**CITY OF TEMPE  
DEVELOPMENT REVIEW COMMISSION**

**Meeting Date: 10/22/2019  
Agenda Item: 03**

**ACTION:** Request a Development Plan Review for a new 8,448 Square-foot addition for **CHAPMAN KYRENE BODYSHOP**, located at 5301 South Kyrene Road. The applicant is Barry R. Barcus Architect, Inc.

**BACKGROUND INFORMATION:** CHAPMAN KYRENE BODYSHOP PL190146 is a proposed 8,448 s.f. addition on the east side of the existing building to house paint preparation rooms, paint booths and a mix room. The request includes the following:

SHEET NO.  
**AS1.00**

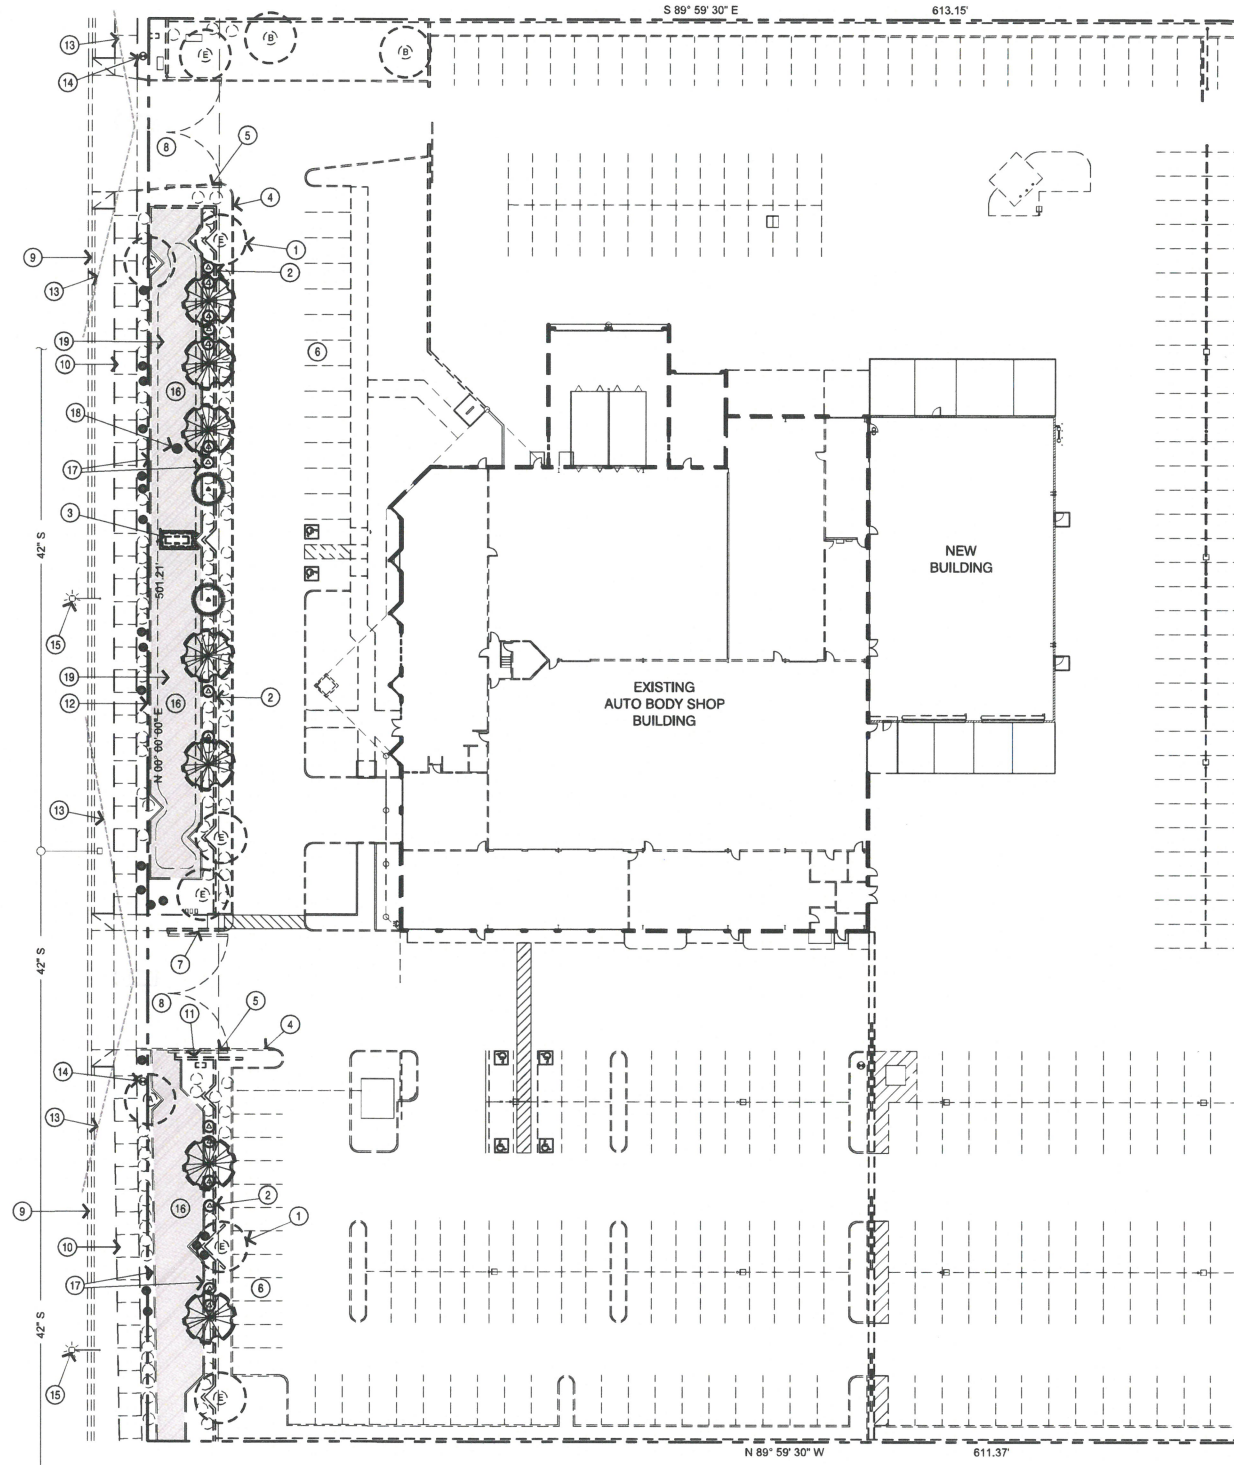
The site is 7.04 acres in size. The proposed addition will be located on the northeast side of the existing building and located within a current inventory lot area. The proposed addition will not affect other buildings or circulation of the site for solid waste and fire vehicles.

2. Provide service yard and mechanical (cooling tower/generator) yard walls that are at least 8'-0" tall as measured from adjacent grade or are at least the height of the equipment being enclosed, whichever is greater. Verify height of equipment and mounting base to ensure that wall height is adequate to fully screen the equipment.

- Correctly indicate clear vision triangles at both driveways on the site and landscape plans. Identify speed limits for adjacent streets at the site frontages. Begin sight triangle in driveways at point 15'-0" in back of face of curb. Consult Intersection Sight Distance memo, available from Traffic Engineering if needed [www.tempe.gov/index.aspx?page=801](http://www.tempe.gov/index.aspx?page=801). Do not locate site furnishings, screen walls or other visual obstructions over 2'-0" tall (except canopy trees are allowed) within each clear vision triangle.

- Clearly define the fire lanes. Ensure that there is at least a 20'-0" horizontal width, and a 14'-0" vertical clearance from the fire lane surface to the underside of tree canopies or overhead structures. Layout and details of fire lanes are subject to Fire Department approval.
- Provide a fire command room(s) on the ground floor of the building(s). Verify size and location with Fire Department.

**L1**

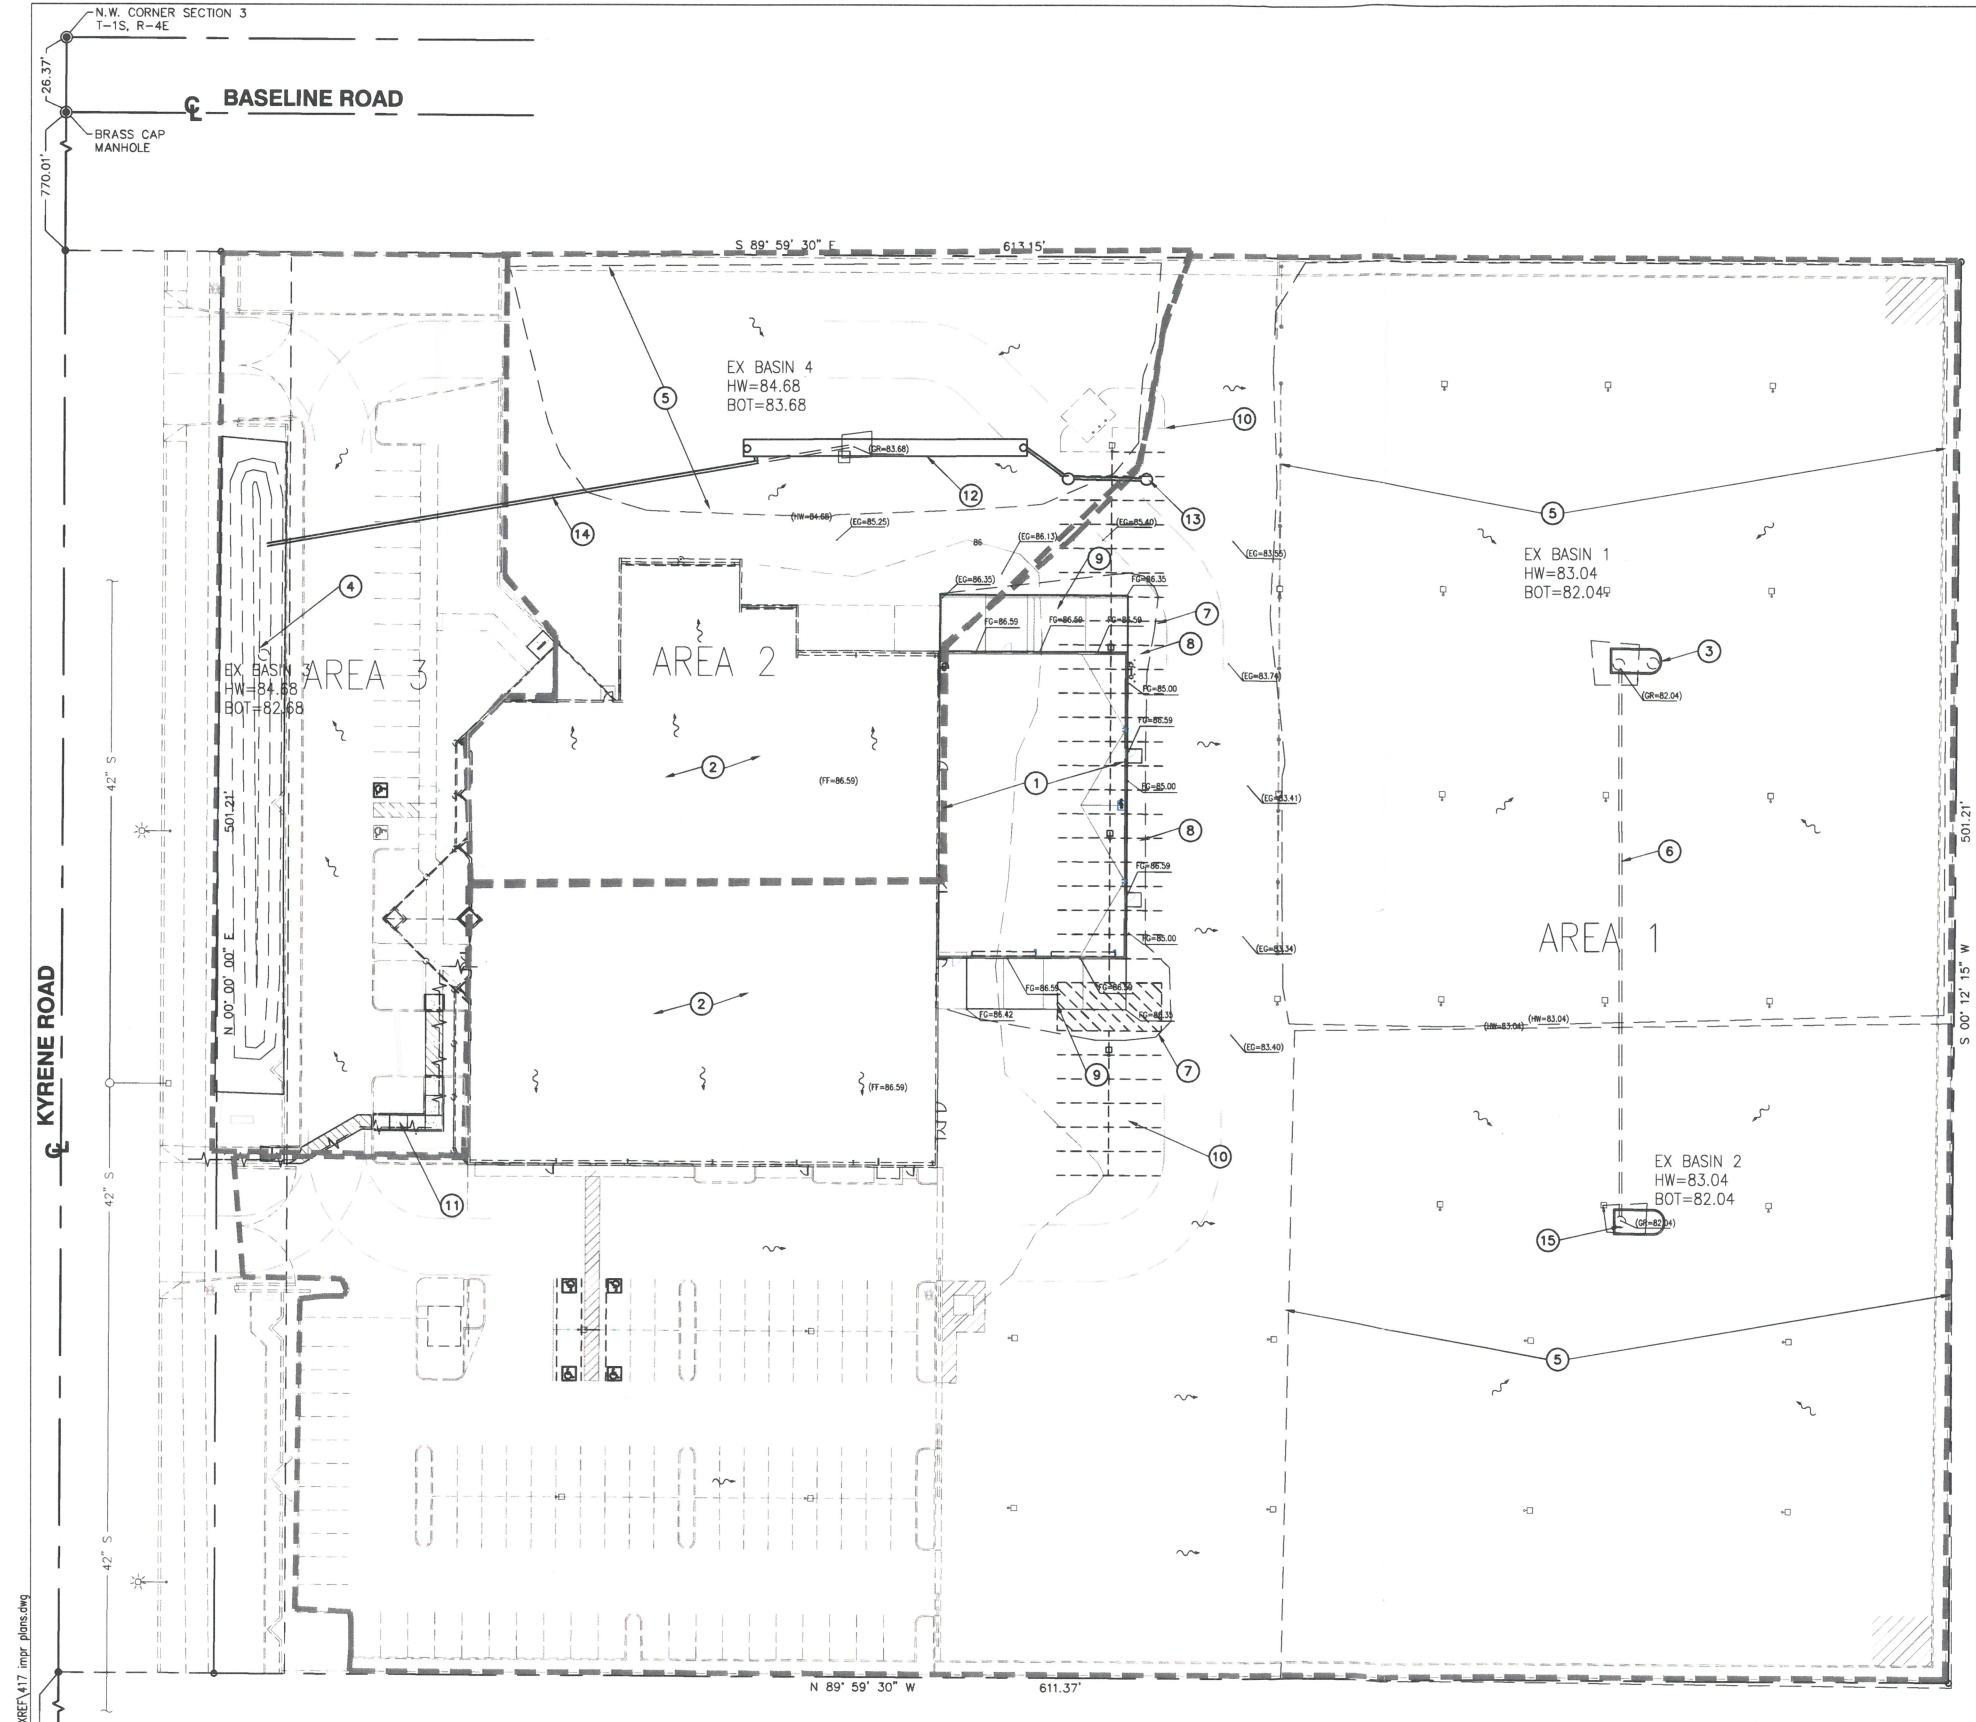
The applicant is proposing minor modifications to the landscape for this project. Primarily replacing dead/missing landscaping as well as adding trees along the frontage to meet the 1 per 30 f.t. code requirement. The landscape coverage will be 10% on-site.

13. Arterial street trees shall be a minimum of 36" box specimens and a minimum of 1 ½" caliper trunk.
14. Irrigation notes:
  - a. Provide dedicated landscape water meter.

16. Top dress planting areas with a rock or decomposed granite application. Provide rock or decomposed granite of 2" uniform thickness. Provide pre-emergence weed control application and do not underlay rock or decomposed granite application with plastic.

**1 WEST ELEVATION**  
SCALE: 3/32" = 1'-0"

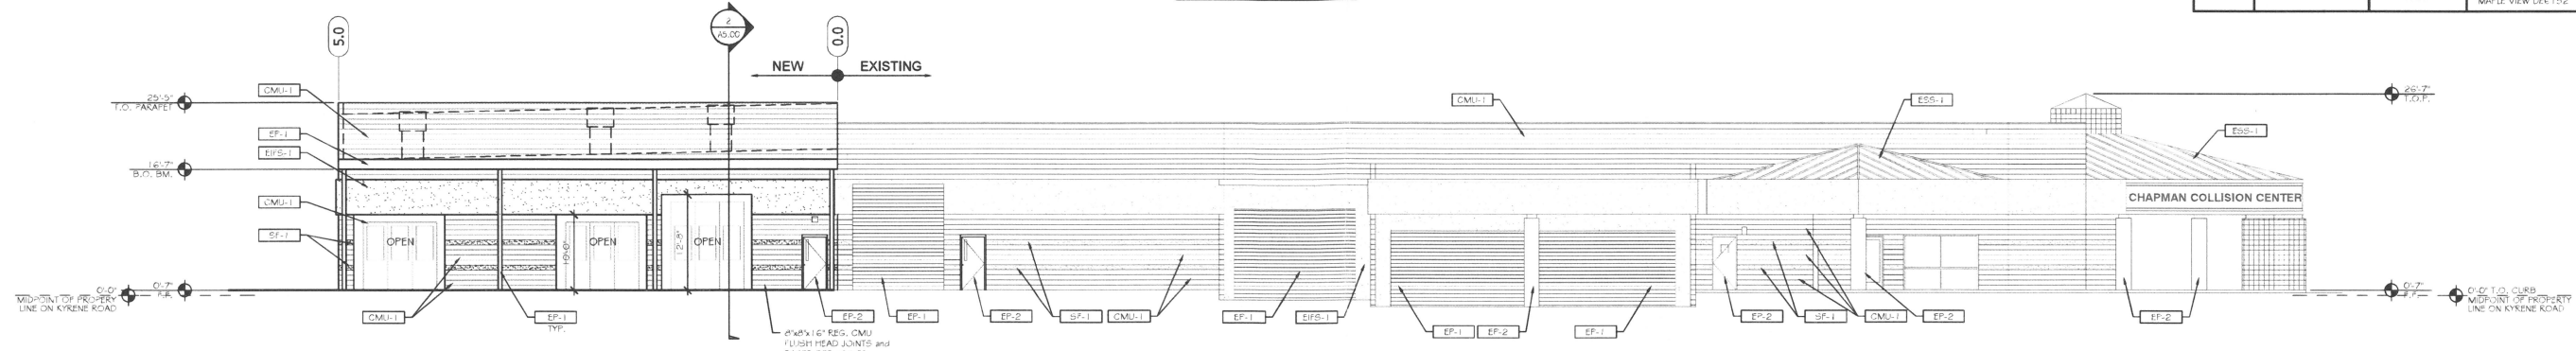
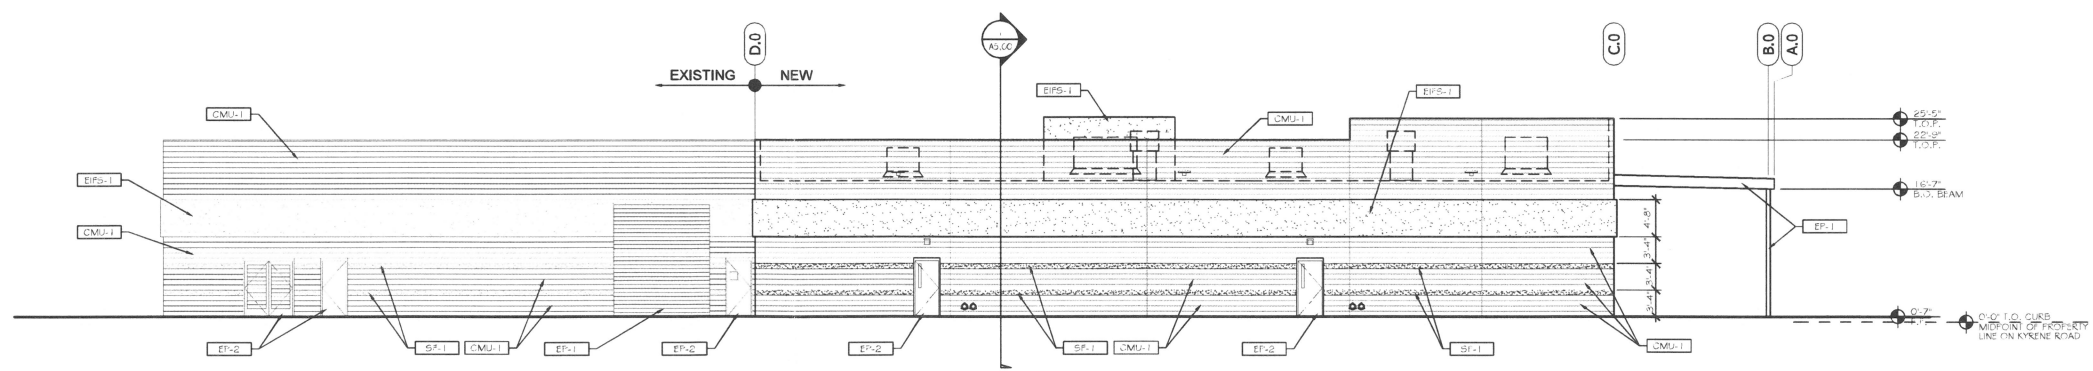
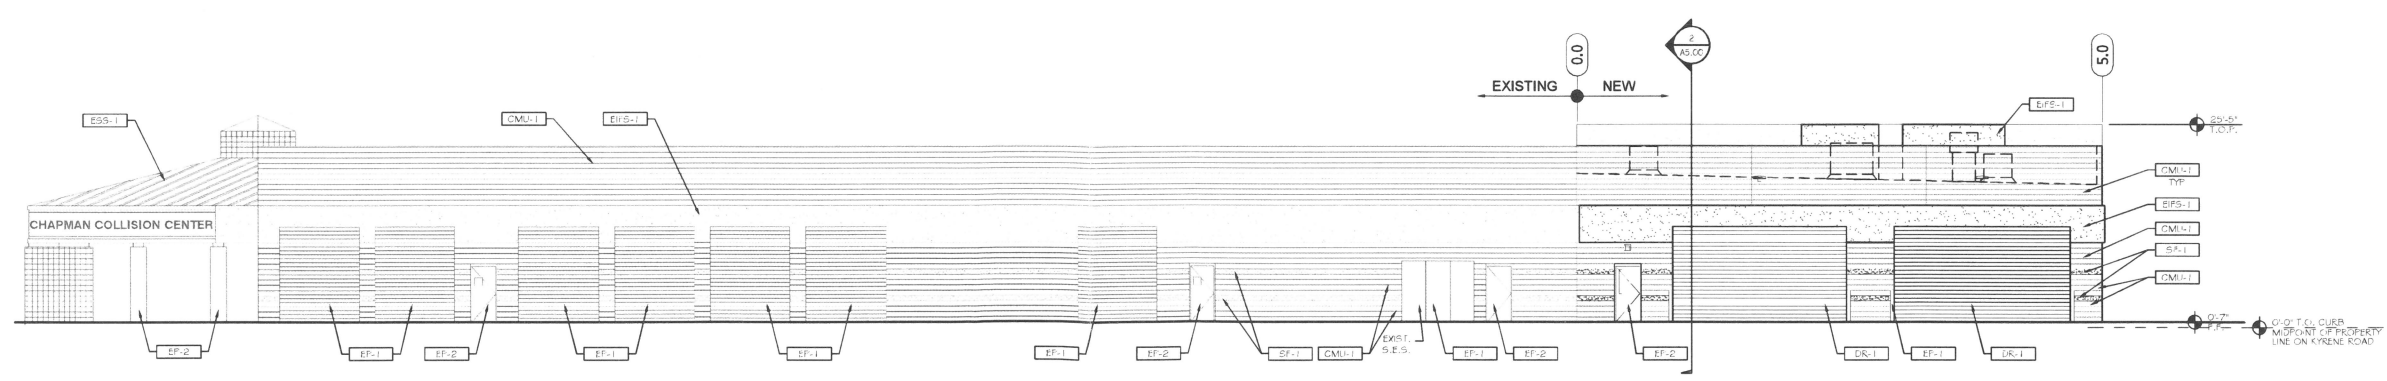
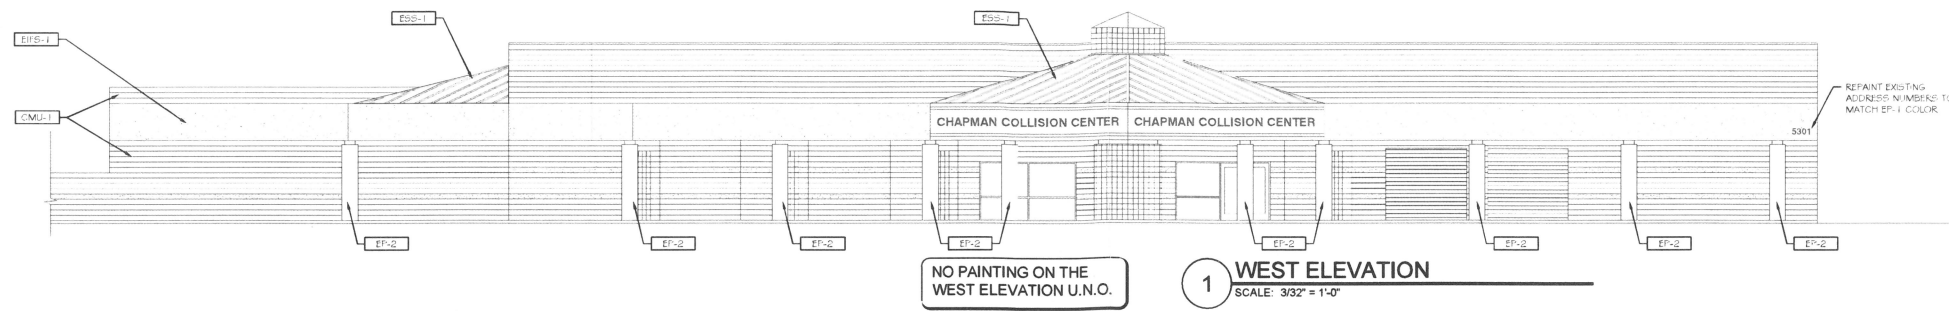
The addition is proposed at a maximum height of 25'-5". All facades are shown to match the design and existing materials of the adjacent building. The north side of the addition will also include a metal canopy painted to match the existing CMU block. Primary materials used for this project is painted CMU (smooth and split-face ribbon accents). As an accent, the doors, columns, and roof will be painted to provide contrast and uniformity to the site along all façades.

6. The materials and colors are approved as presented:

Building Addition – Smooth-faced CMU – Painted to match existing building – Dunn Edwards – Exclusive Ivory DE6191

Building Accent – EIFS – Integral colored & Painted to match existing building – Dunn Edwards – Exclusive Ivory DE6191

Building Accent – Split-faced CMU – Painted to match existing building – Dunn Edwards – Exclusive Ivory DE6191

Roof, Column, & Door accent – Dunn Edwards – Maple View DE6152

Metal awning – Painted to match existing building – Dunn Edwards – Exclusive Ivory DE6191

Provide primary building colors and materials with a light reflectance value of 75 percent or less.
